DESIGN REVIEW COMMITTEE

700 Doug Davis Drive
Hapeville, GA 30354

May 17, 2023 6:00 PM

AGENDA

PROPOSED FLOOR PLAN -
ELECTRICAL LOWER LEVEL

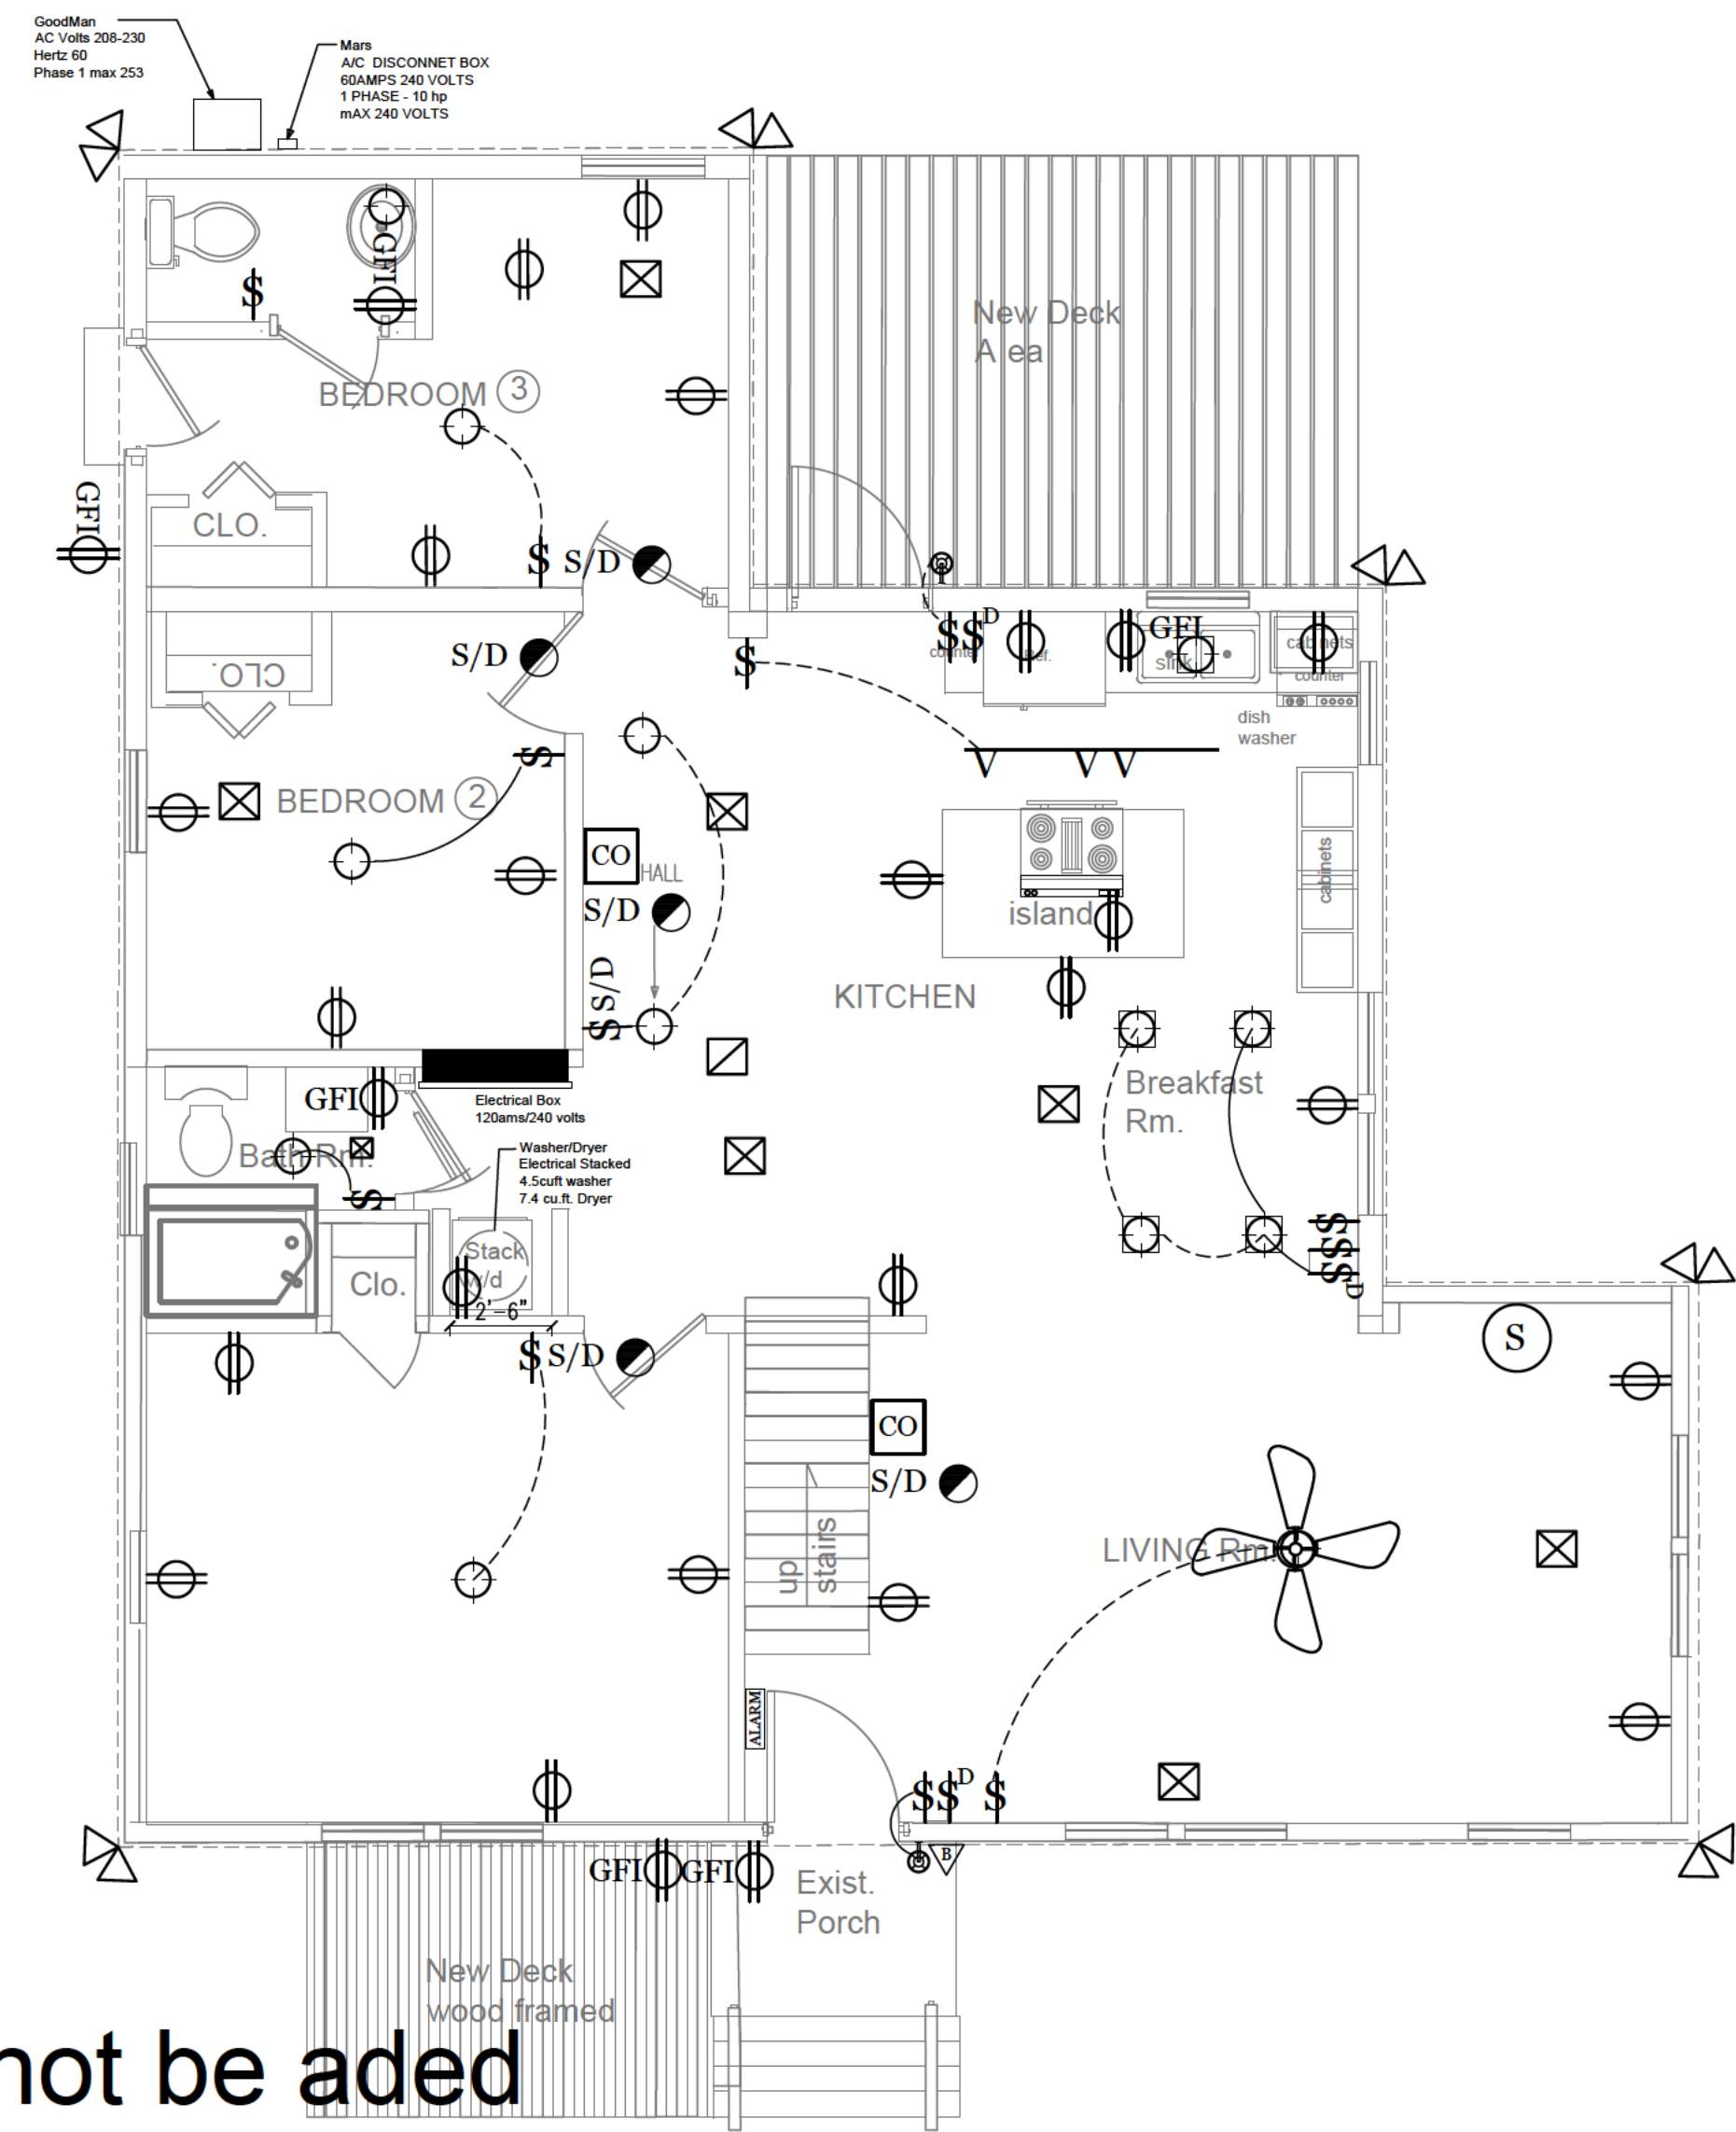
- Ensure that windows are not GBG. Only second floor windows in front are called out this way.
- Note: please have the front deck removed from the drawings. This is not approved.
- Correct Sheet 1 that references the overhang as 1/2" not 12".

Deck will not be added
